Schematic Review Form

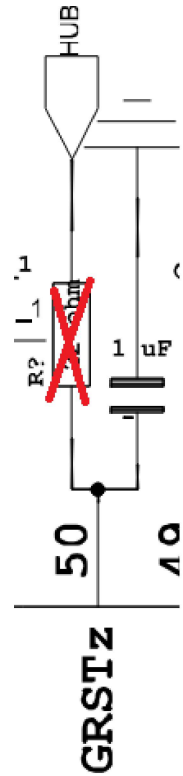
Pin #	Name	Info	Violations	Description
1	USB_DP_DN1	to DS1 connector	▲ ▼	USB2 DOWNSTREAM PORT 1 +
2	USB_DM_DN1			USB2 DOWNSTREAM PORT 1 -
3	USB_SSTXP_DN1	has 100nf cap		USB3 DOWNSTREAM PORT 1 TXP
4	USB_SSTXN_DN1	has 100nf cap		USB3 DOWNSTREAM PORT 1 TXN
5	VDD_1		need 0.1uf and 0.01uf decoupling cap	1.1V SUPPLY
6	USB_SSRXP_DN1	has 330nf cap		USB3 DOWNSTREAM PORT 1 RXP
7	USB_SSRXN_DN1	has 330nf cap		USB3 DOWNSTREAM PORT 1 RXN
8	VDD_2		need 0.1uf and 0.01uf decoupling cap	1.1V SUPPLY
9	USB_DP_DN2	to DS2 connector		USB2 DOWNSTREAM PORT 2 +
10	USB_DM_DN2			USB2 DOWNSTREAM PORT 2 +
11	USB_SSTXP_DN2	has 100nf cap		USB3 DOWNSTREAM PORT 2 TXP
12	USB_SSTXN_DN2	has 100nf cap		USB3 DOWNSTREAM PORT 2 TXN
13	VDD_3		need 0.1uf and 0.01uf decoupling cap	1.1V SUPPLY
14	USB_SSRXP_DN2	has 330nf cap		USB3 DOWNSTREAM PORT 2 RXP

15	USB_SSRXN_DN2	has 330nf cap		USB3 DOWNSTREAM PORT 2 RXN
16	VDD33		need 0.1uf and 0.01uf decoupling cap	3.3V SUPPLY
17	USB_DP_DN3	to DS3 connector		USB2 DOWNSTREAM PORT 3 +
18	USB_DM_DN3			USB2 DOWNSTREAM PORT 3 -
19	USB_SSTXP_DN3	has 100nf cap		USB3 DOWNSTREAM PORT 3 TXP
20	USB_SSTXN_DN3	has 100nf cap		USB3 DOWNSTREAM PORT 3 TXN
21	VDD_4		need 0.1uf and 0.01uf decoupling cap	1.1V SUPPLY
22	USB_SSRXP_DN3	has 330nf cap		USB3 DOWNSTREAM PORT 3 RXP
23	USB_SSRXN_DN3	has 330nf cap		USB3 DOWNSTREAM PORT 3 RXN
24	USB_DP_DN4		port 4 is not used?	USB2 DOWNSTREAM PORT 4 +
25	USB_DM_DN4			USB2 DOWNSTREAM PORT 4 -
26	USB_SSTXP_DN4			USB3 DOWNSTREAM PORT 4 TXP
27	USB_SSTXM_DN4			USB3 DOWNSTREAM PORT 4 TXN
28	VDD_5		need 0.1uf and 0.01uf decoupling cap	1.1V SUPPLY
29	USB_SSRXP_DN4			USB3 DOWNSTREAM PORT 4 RXP
30	USB_SSRXN_DN4			USB3 DOWNSTREAM PORT 4 RXN
31	VDD_6		need 0.1uf and 0.01uf decoupling cap	1.1V SUPPLY

32	PWRCTL4/BATEN4		pin 40 shows power switching is supported ▲ ▼	USB Port 4 Power On Control for Downstream Power/Battery Charging Enable
33	PWRCTL3/BATEN3		pin 40 shows power switching is supported ▲ ▼	USB Port 3 Power On Control for Downstream Power/Battery Charging Enable
34	VDD33_2		need 0.1uf and 0.01uf decoupling cap	3.3V SUPPLY
35	PWRCTL2/BATEN2		pin 40 shows power switching is supported ▲ ▼	USB Port 2 Power On Control for Downstream Power/Battery Charging Enable
36	PWRCTL1/BATEN1		pin 40 shows power switching is supported ▲ ▼	USB Port 1 Power On Control for Downstream Power/Battery Charging Enable
37	SDA/SMBDAT	floating ▲ ▼		I2C data/SMBus data
38	SCL/SMBCLK	floating		I2C clk/SMBus clk
39	SMBUSz/SS_SUSPEND	floating, in I2C mode		I2C/SMBus mode select/SuperSpeed USB Suspend Status
40	FULLPWRMGMTz/SMBA1/SS_UP	external pulldown to support power switching		Full power management enable
41	PWRCTL_POL	external pullup, power switching active high		Power Control Polarity

42	GANGED/SMBA2/ HS_UP	external pulldown to support individual port	all downstream ports use the same Vbus	Ganged operation enable
43	OVERCUR4z			USB Port 4 Over-Current Detection
44	OVERCUR3z			USB Port 3 Over-Current Detection
45	AUTOENZ/ HS_SUSPEND	pulldown to enable auto mode battery charging		Automatic Charge Mode Enable/
46	OVERCUR1z			USB Port 1 Over-Current Detection
47	OVERCUR2z			USB Port 2 Over-Current Detection
48	USB_VBUS	0.5v on USB_VBUS 	make sure its 90k/10k divider	Vbus detect
49	TEST	4.7k pulldown to ground		This pin is reserved for factory test.
50	GRSTz		no need 22 ohm resistor	Global power reset

51	VDD_7		need 0.1uf and 0.01uf decoupling cap	1.1V SUPPLY
52	VDD33_2		need 0.1uf and 0.01uf decoupling cap	3.3V SUPPLY
53	USB_DP_UP			USB2 UPSTREAM PORT +
54	USB_DM_UP			USB2 UPSTREAM PORT -
55	USB_SSTXP_UP	has 100nf cap		USB3 UPSTREAM PORT TXP
56	USB_SSTXN_UP	has 100nf cap		USB3 UPSTREAM PORT TXN
57	VDD_8		need 0.1uf and 0.01uf decoupling cap	1.1V SUPPLY
58	USB_SSRXP_UP	has 330nf cap		USB3 UPSTREAM PORT RXP

59	USB_SSRXN_UP	has 3300nf cap		USB3 UPSTREAM PORT RXN
60	NC			NC PIN
61	XO	24Mhz crystal		Crystal output
62	XI			Crystal input
63	VDD33_4		need 0.1uf and 0.01uf decoupling cap	3.3V SUPPLY
64	USB_R1	9.53k pulldown resistor

- 1: is upstream port connected to USB connector or to host directly
- 2: FULLPWRMGMTz is low, but Vbus switch is not controlled by PWRCTLx pin
- 3: GANGed pin is low, but all downstream port shared the same Vbus
